STAFF REPORT: 7/13/2022 REGULAR MEETING

APPLICATION NUMBER: #22-7900

ADDRESS: 757 COVINGTON

SCOPE: REMOVE REAR WALL FOUNTAIN, REBUILD GABLE/PARAPET, INSTALL GLASS BLOCK WINDOW

Site Photo 2 by Applicant: (South) rear elevation, showing courtyard wall fountain proposed for removal.

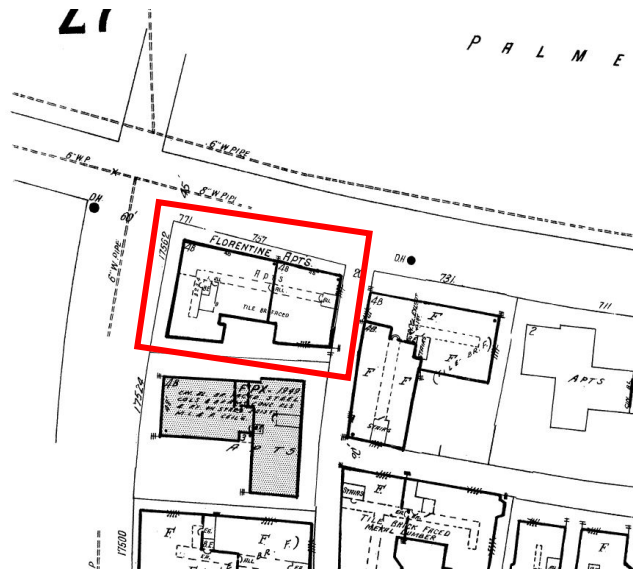
- Staff observed that the applicant's rationale for removing the rear courtyard features were provided in a letter, dated June 15, 2022, where the applicant describes the features being in bad condition, the source of brick was not available, and the walls served as a source of complaint from residents as a safety concern.

Recommendation #1: Removal of courtyard walls, fountain and features, replacement of wood windows #1-3

Staff finds that the removal of the courtyard walls and elements and the replacement of wood windows #1-3 as described in this proposal alters the historic character of this property and removes distinctive, character-defining features.

Staff therefore recommends that the Commission issue a Denial for the above work items, as they do not meet the Secretary of the Interior's Standards for Rehabilitation, specifically Standards:

1. Remove wall fountain (rear elevation)

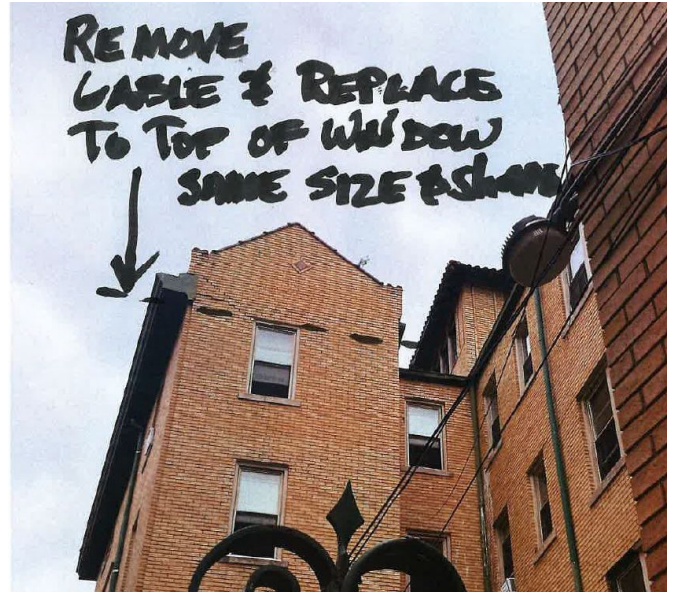
- Remove all features of the rear wall, fountain
- Retain brick for building repair

SOUTH SIDE REAR OF BUILDING

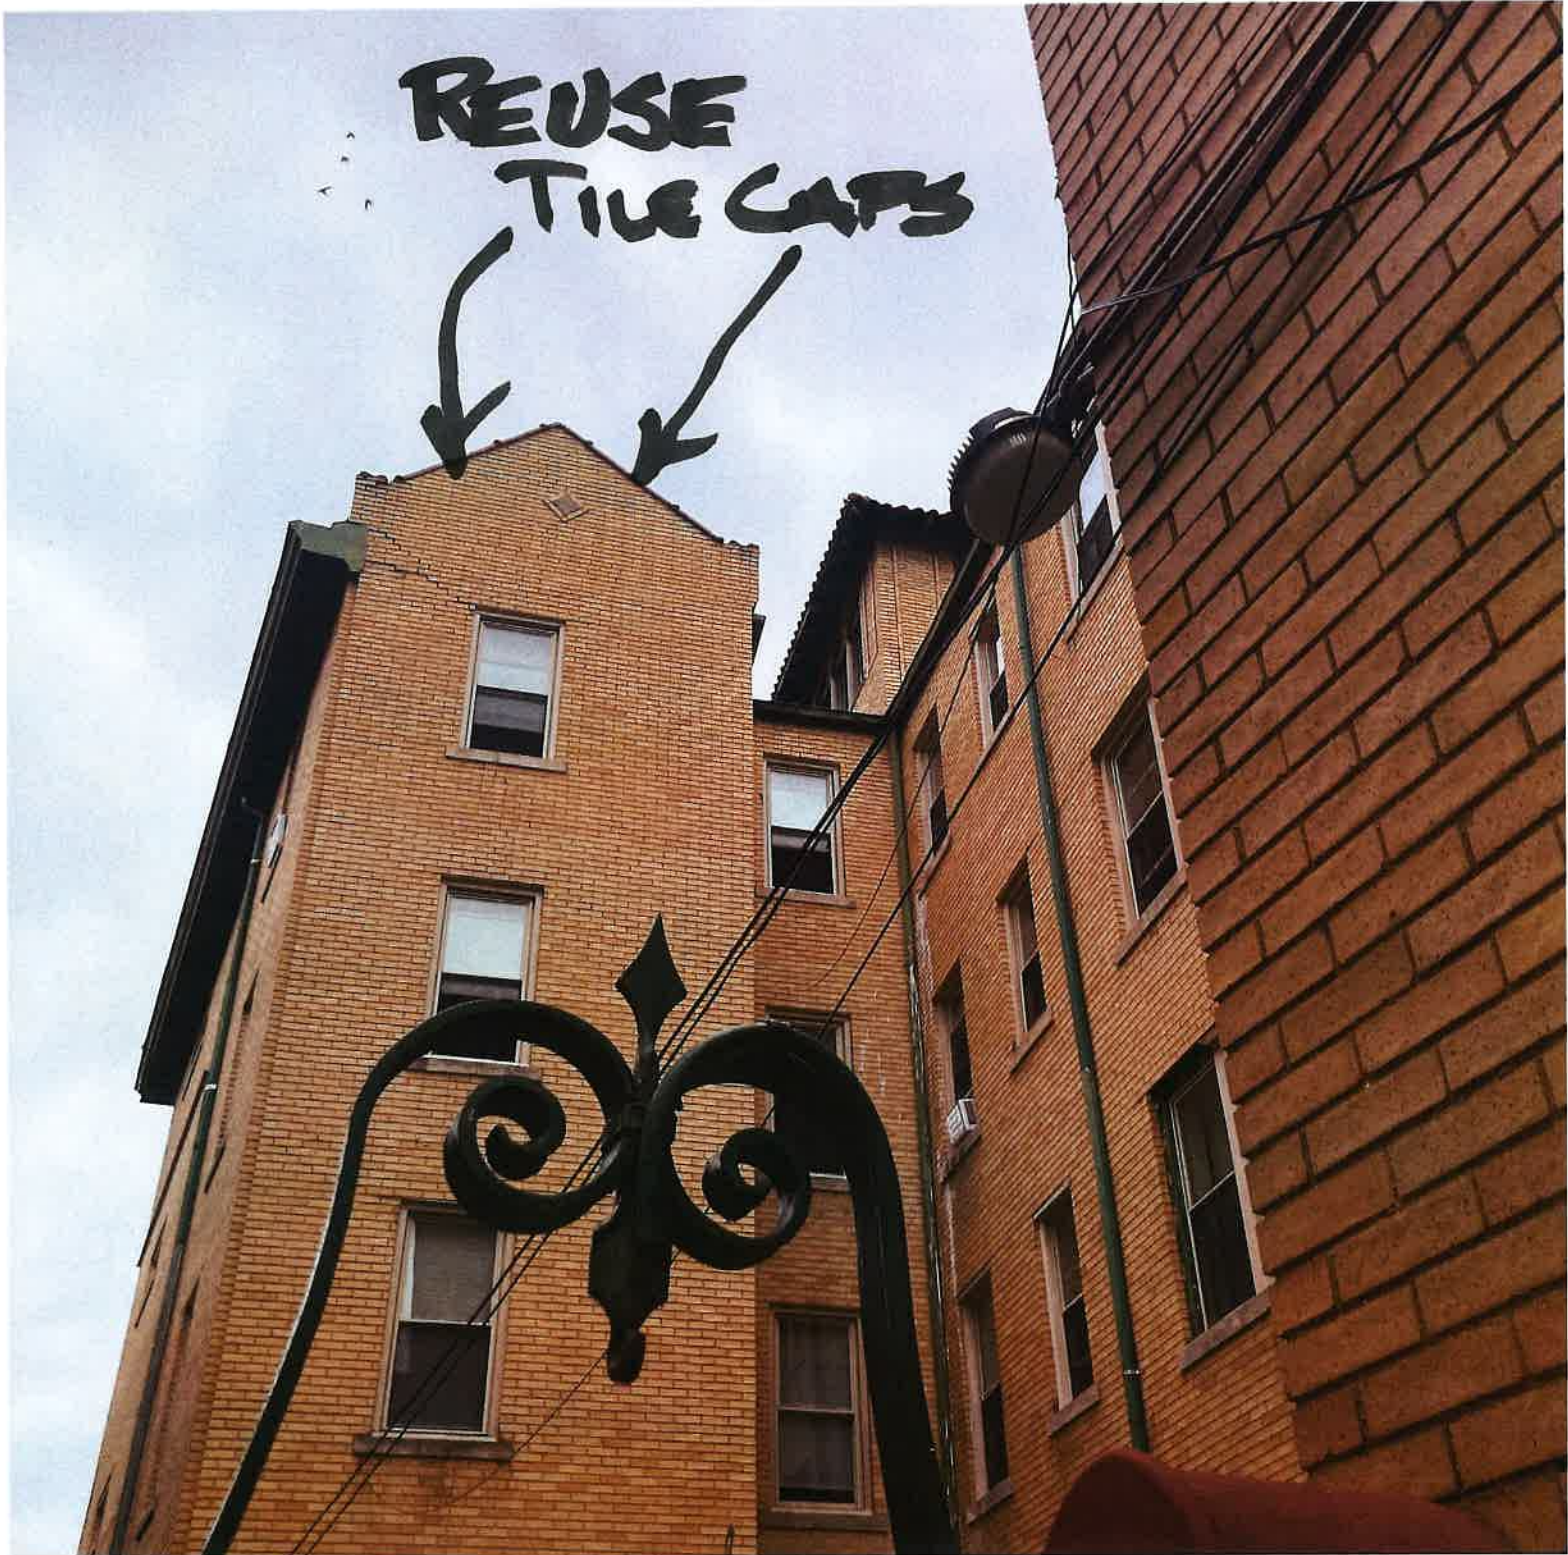
1. Please provide dimensions on the areas that will be impacted by the rebuilding of the wall and the parapet. You provide area dimensions on a photograph with a description of how this process will be repaired- are you removing and replacing the coping? Is the tile detail going to be preserved and replaced? Please describe.

REMOVE AND REPLACE
USING BRICK FROM
LANDSCAPE FEATURE

**REMOVE
CABLE & REPLACE
TO TOP OF WINDOW
SAME SIZE & SHANE**

REUSE
TILE CAPS

- The clay brick be of a color, dimension and finish that approximates the existing brick of the gable wall and rear courtyard brick.
- Staff receive a final plan showing product and detail description of the above work.
- The applicant provides HDC staff a review of the above items before installation.

THE AREA TO BE REPLACED IS FROM TOP OF WINDOW UP. IT IS 20' WIDE AND 10' TALL AT THE PEAK. WE ARE REMOVING BRICK USING A SCISSOR LIFT TO TAKE IT APART, BRING BRICKS TO THE GROUND, INSTALKL NEW STEEL LINTEL AND INSTALL CLEANED EXISTING BRICKS FROM THE GABLE AND THE LANDSCAPE AREA. THE BRICK ON THE LANDSCAPE FEATURE COME APART EASILY AND WILL BE CLEANED OF MORTAR AND REUSED. THE COPING AT THE TOP WILL BE REUSED OR IF BROKEN REPLACED WITH EXACTLY SAME SHAPE AND COLOR

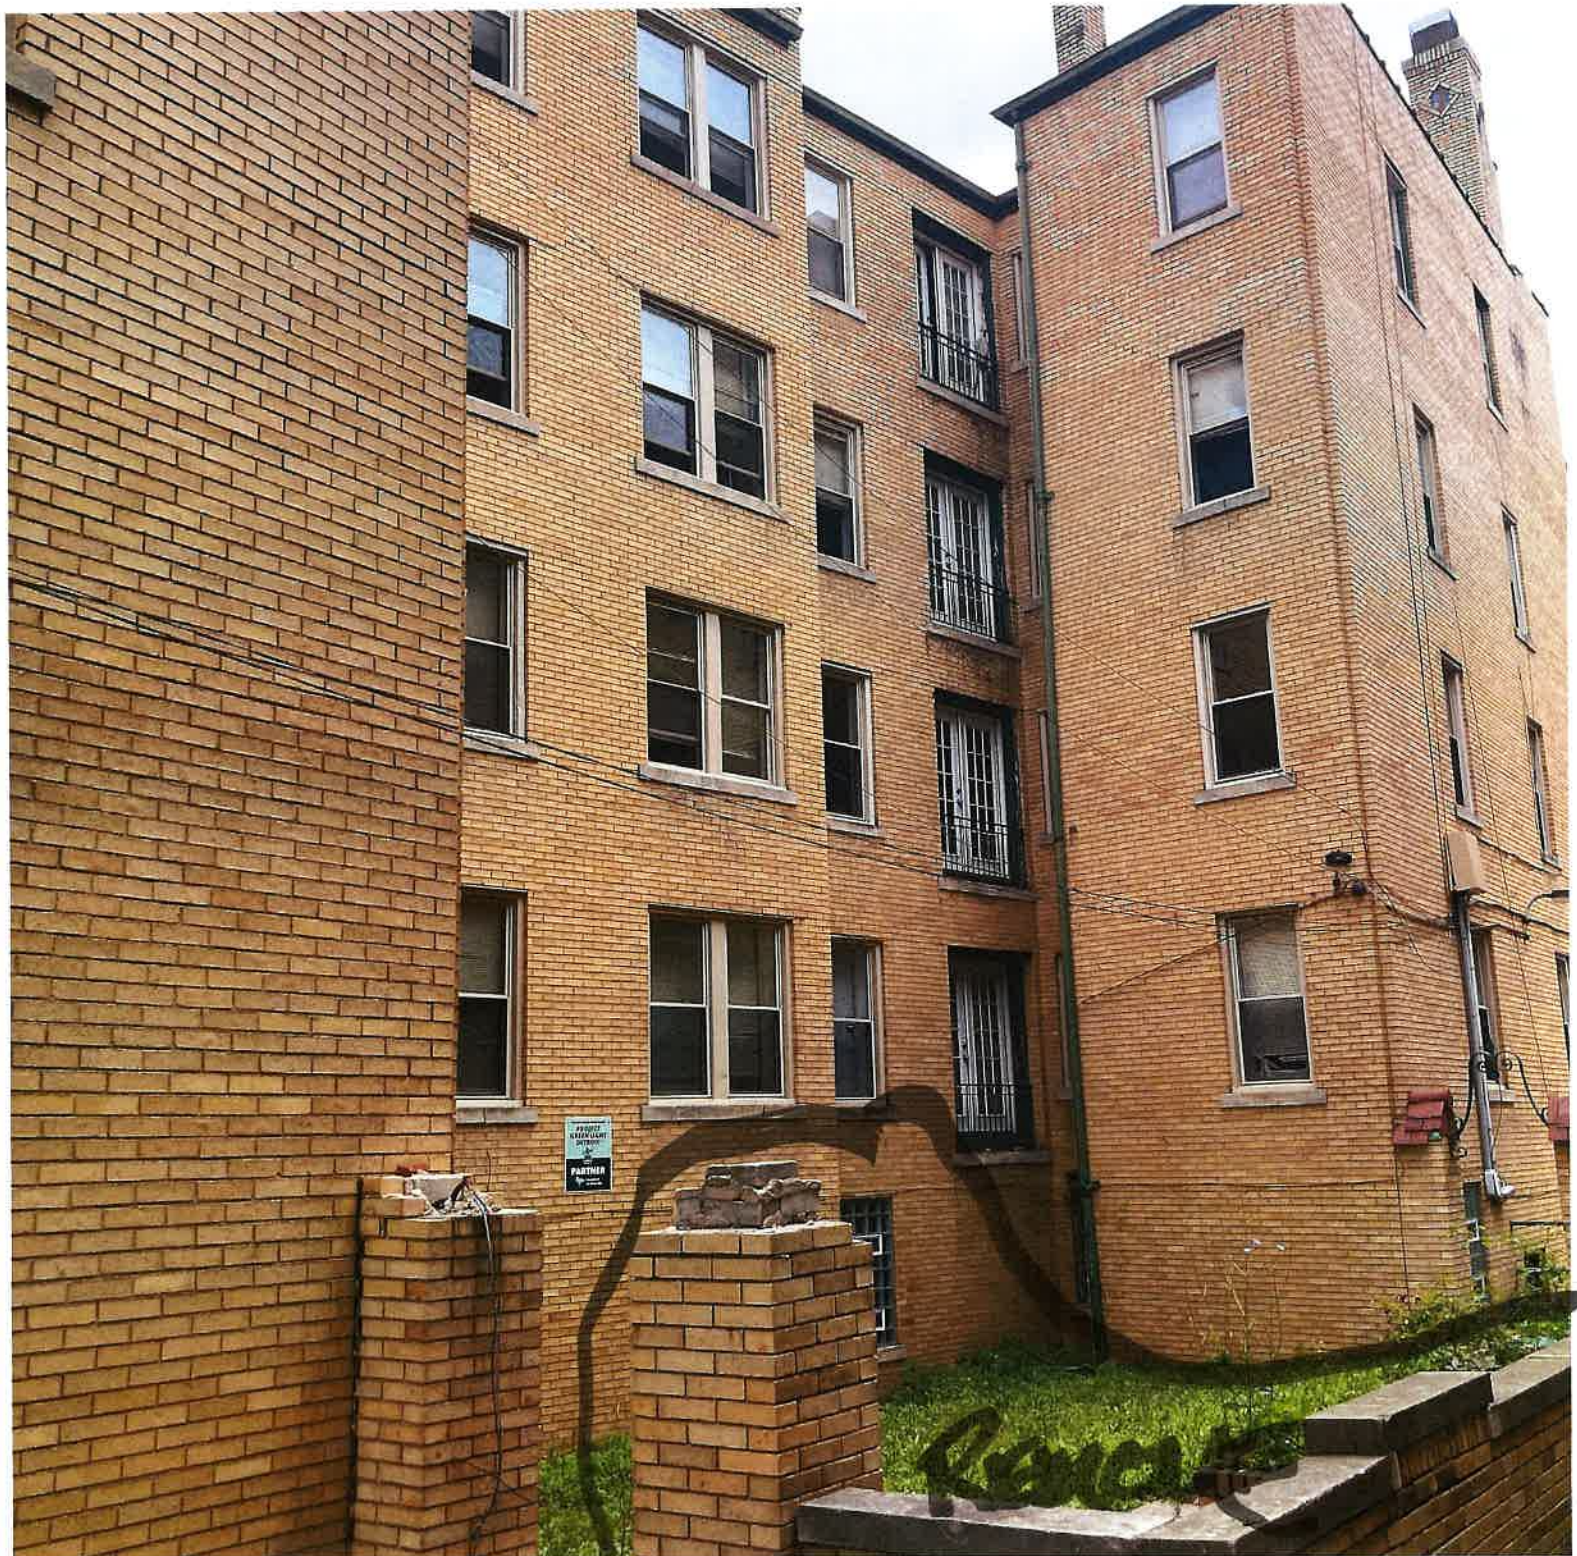
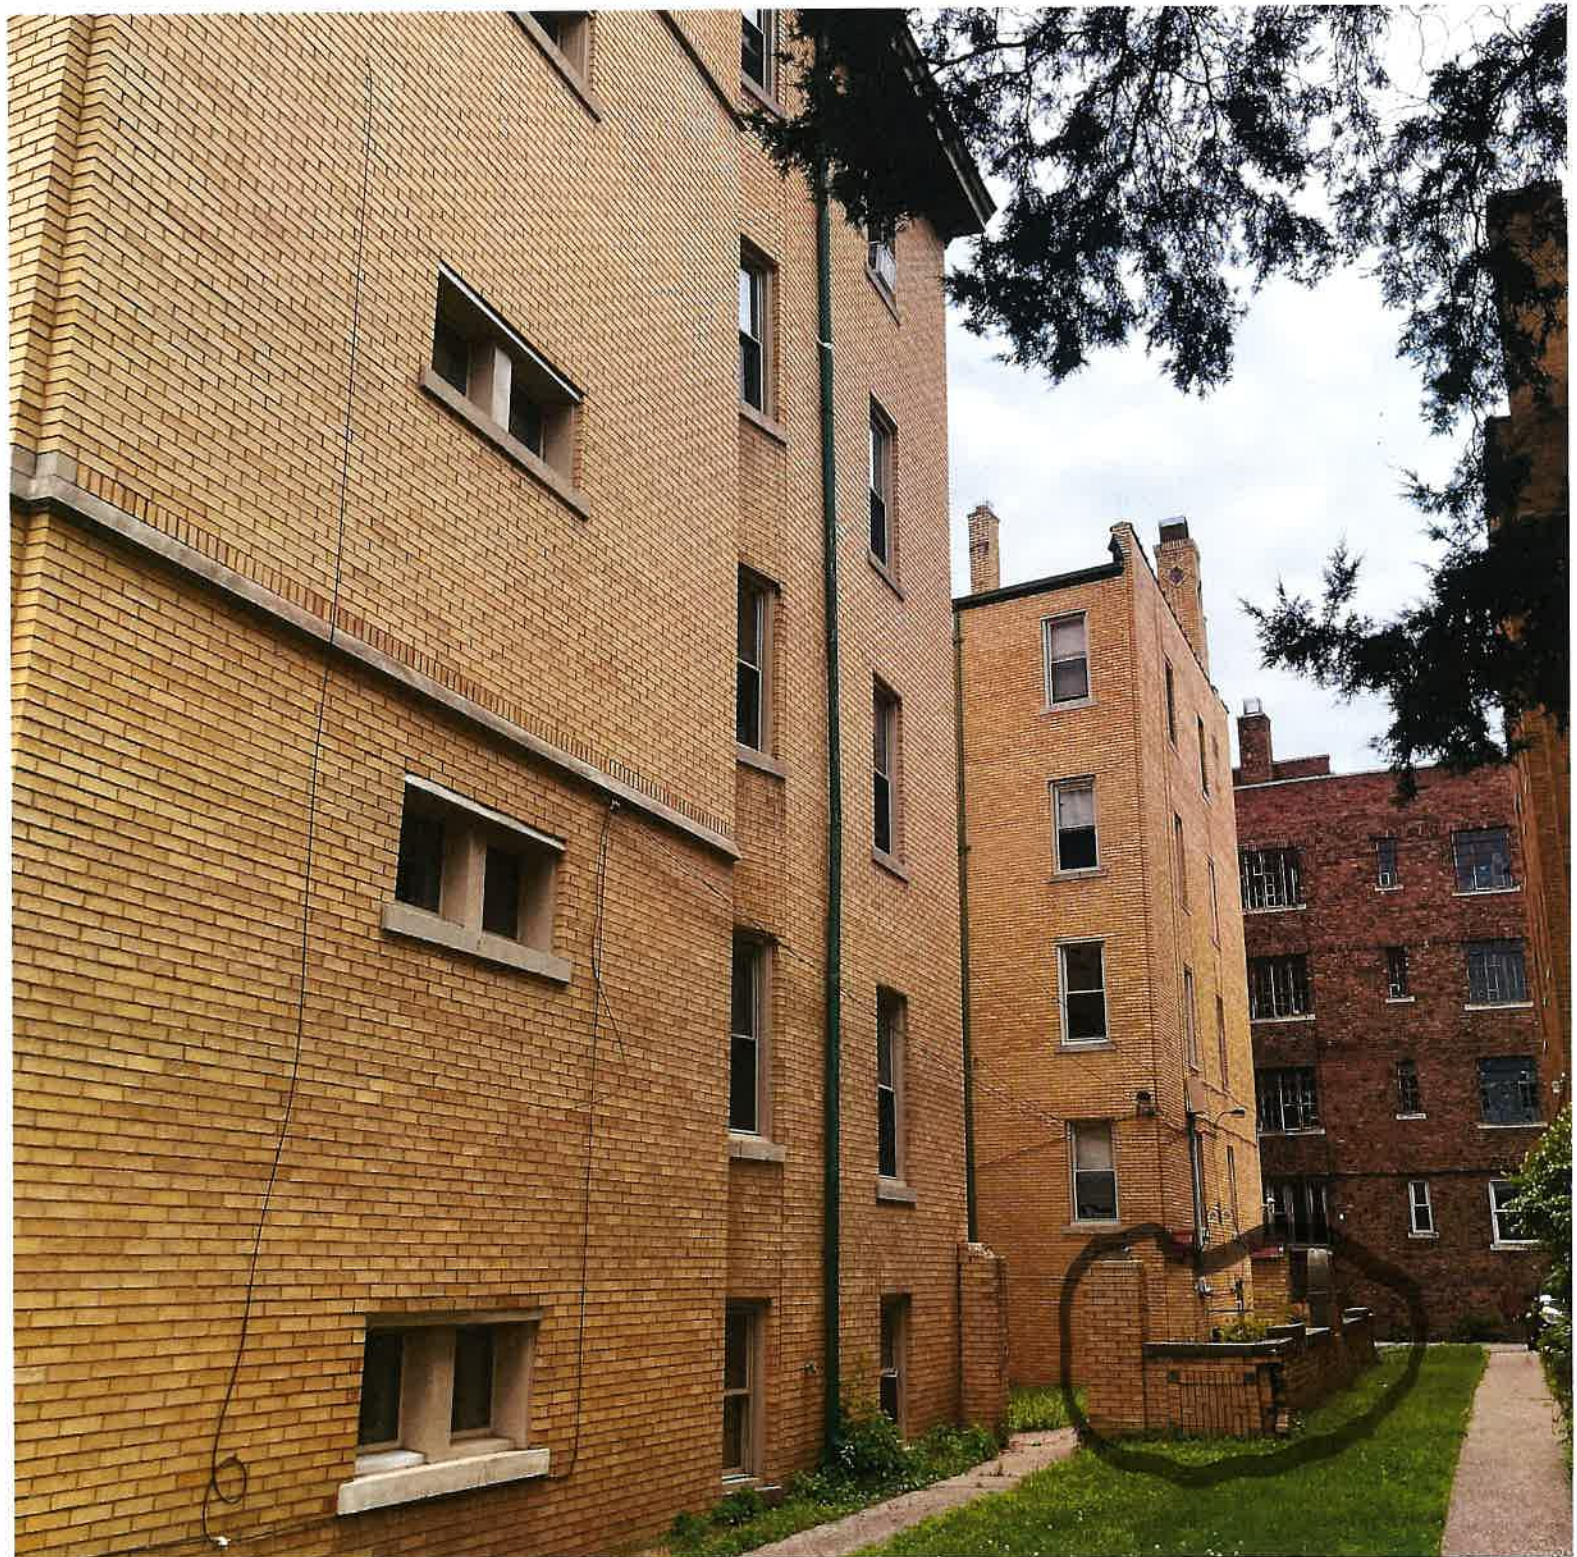
- Staff recommends that the replacement of the rear double hung windows (#1-3) with glass block and the removal/demolition of the courtyard walls, brick piers, wall fountain or any of the courtyard components alters the historic character of the property (Standards 2 and 3), removes distinctive features (Standard 5), and the windows should be repaired rather than replaced (Standard 6).
- The conditions of the courtyard and its distinctive, character-defining features have been left in disrepair, allowing further damaging conditions to continue.
- An alternative source of brick for the repair of the brick wall gable/parapet has not been provided.
- It is Staff's opinion that location of window #4 is not at a primary or even secondary location and would meet the conditions for an appropriate replacement with glass block windows.

BRICK
CONCRETE
PART
EASY TO
RE USE

REMOVE

GLASS
BLOCK

REMOVE
& RE-USE
BRICK

GLASS
BLOCK

THERE WILL BE NO VENTS IN THE 4 GLASS BLOCK WINDOWS AND THEY WILL BE INSTALLED ACCORDING TO THE INSTALLATION SHEET IN THE HDC APPLICATION
